CITY OF NOVI CITY COUNCIL AUGUST 8, 2022

SUBJECT: Final approval at the request of Toll Brothers, LLC of Parc Vista (fka Covington Estates), JSP21-47, Residential Unit Development (RUD) Plan and Agreement. The subject property is located on 54.3 acres in Section 31, north of Eight Mile Road and west of Garfield Road in the RA, Residential Acreage District. The applicant is proposing a 44-unit single-family development.

PLAN REVIEW CENTER REPORT

TOLL BROTHERS
PARC VISTA BY TOLL BROTHERS
RESIDENTIAL UNIT DEVELOPMENT PLAN
UTILITY PLAN

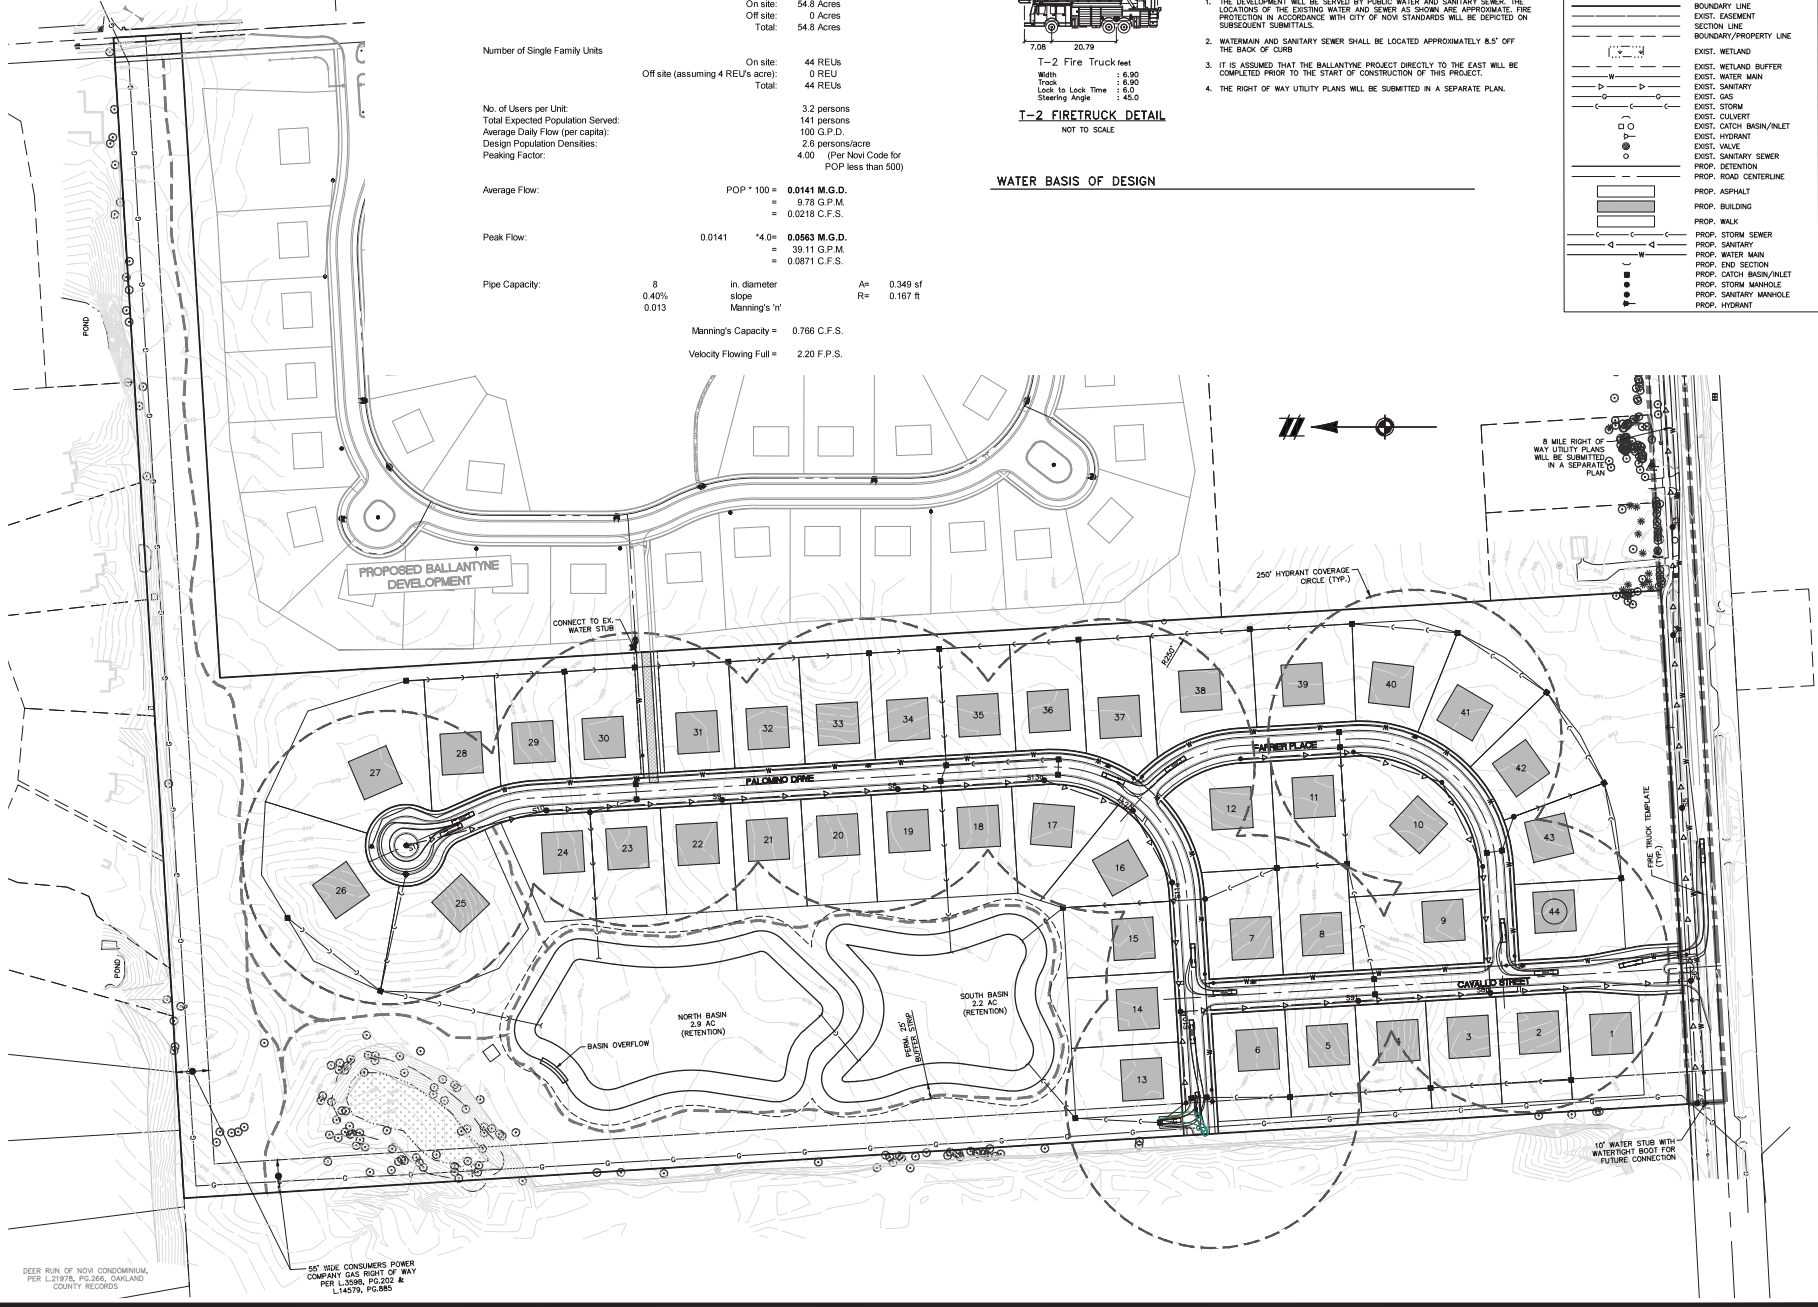
5. RUD Intent - The applicant has provided a written statement, however it is not clear how the open space to be preserved will be permanently protected. Will an Open Space Preservation Easement be granted? In addition, Sheet 6 of the plan set indicates 3.2 persons per unit for a total population of 141 persons, while the narrative indicates a total population of 176 people. Please clarify the inconsistency.

Response: *Refer to the response to planning comment #1 with regard to the open space preservation. The total population of 141 persons is the correct population (as depicted in the Sanitary Basis of Design on Sheet 6).*

SECTION: 31
TOWN: 01 NORTH, RANGE: 08 EAST
CITY: OF NOV
OAKLAND COUNTY, MICHIGAN
DETAIL SHEET

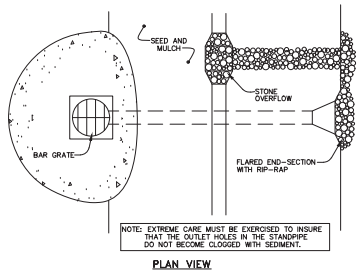
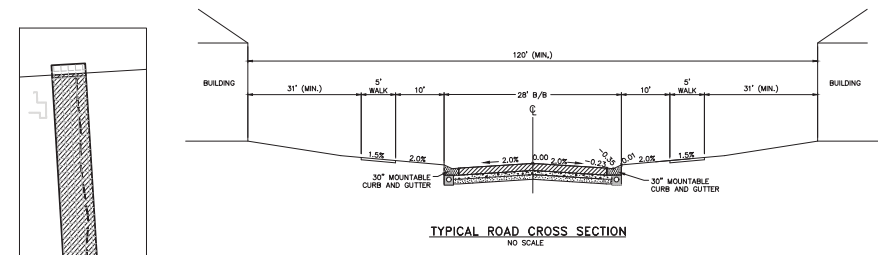
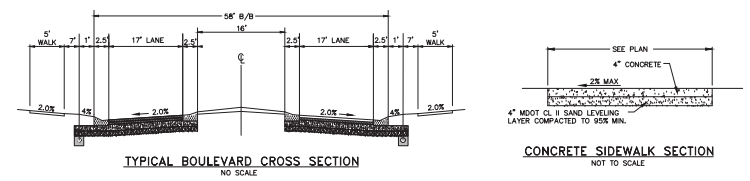
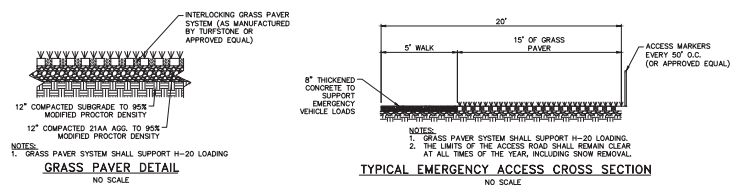
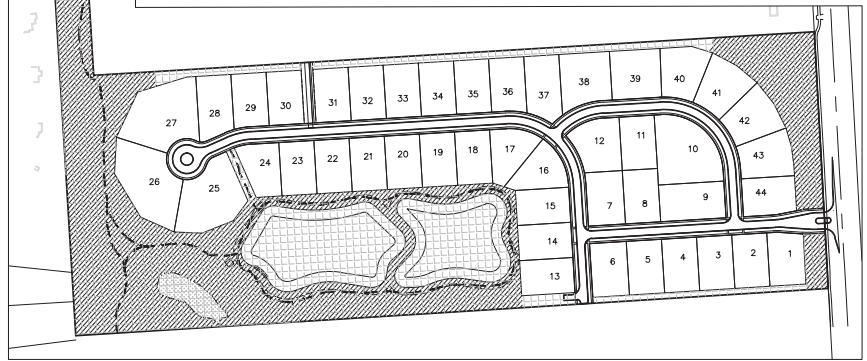
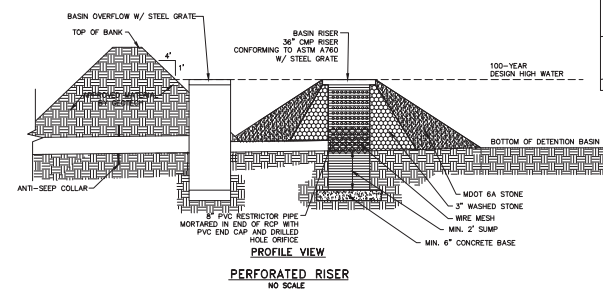
48. Remove perforated riser detail from sheet 10.
Response: *This detail will be removed on subsequent plan submittals.*
49. Design construction standards state that ponds (basins) shall be designed as an integral part of the overall site plan and shall be considered a natural landscape feature having an irregular shape. It is recommended that the basin have a more natural shape.
